SOLICITATION AMENDMENT MODIFICATION DE L'INVITATION

Title - Sujet Sea Containers	
Solicitation No. - N° de l'invitation W355B-207222/B	Amendment No. - N° modif. 001
Client Reference No. - N° de référence du client W355B-20-7222	Date 2020-08-12
GETS Reference No. - N° de référence de SEAG PW-SHAL-406-11023	
File No. - N° de dossier HAL-9-83081 (406)	CCC No./N° CCC - FMS No./N° VME
Solicitation Closes - L'invitation prend fin at - à 02:00 PM on - le 2020-08-27	Time Zone Fuseau horaire Atlantic Daylight Saving Time ADT
F.O.B. - F.A.B. Plant-Usine: <input type="checkbox"/> Destination: <input checked="" type="checkbox"/> Other-Autre: <input type="checkbox"/>	
Address Enquiries to: - Adresser toutes questions à: Matheson, Valerie	Buyer Id - Id de l'acheteur hal406
Telephone No. - N° de téléphone (902) 403-6236 ()	FAX No. - N° de FAX (902) 496-5016
Destination - of Goods, Services, and Construction: Destination - des biens, services et construction:

Amendment 001 is issued to respond to questions and to extend the closing date

PROJECT: SHIPPING CONTAINER LAYOUT

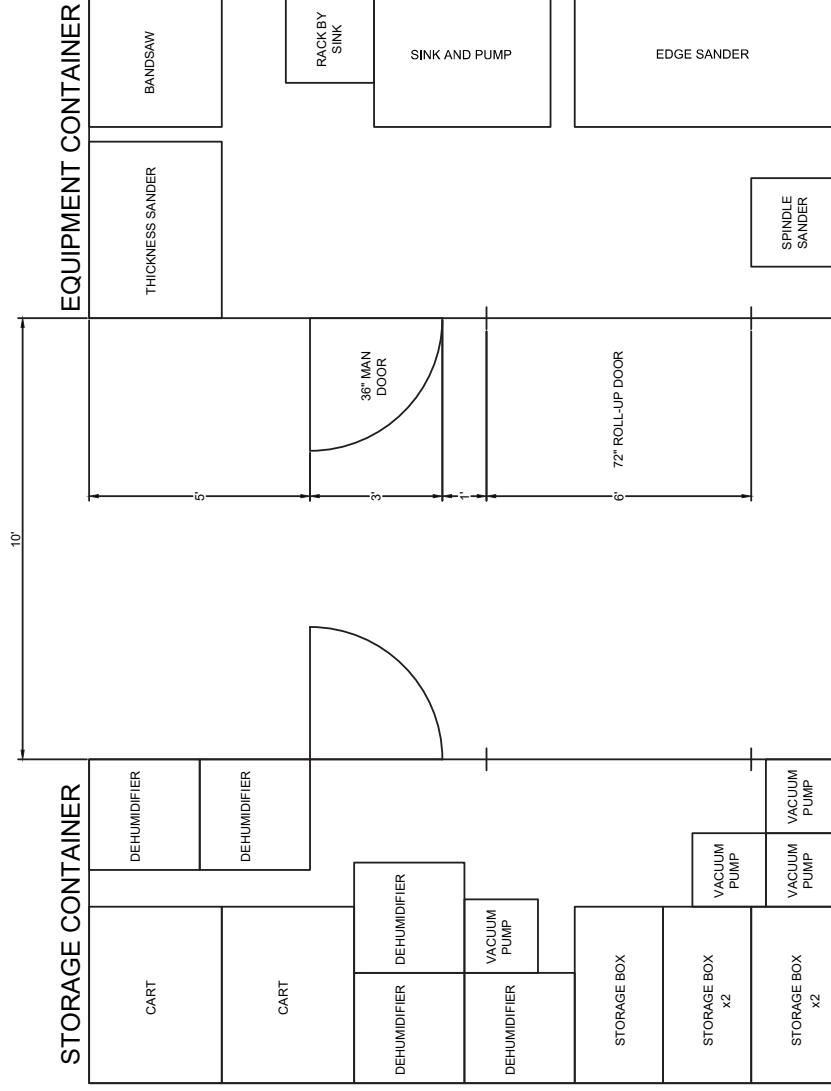
Q1: 4.1.1 Technical Evaluation
MANDATORY requirement at Solicitation closing date:

1. Bidder must provide proposed design drawings with all the required specifications for each container for evaluation purposes.

Do you have any information on the equipment going inside the containers?

A1: See copy of proposed layout for each container.
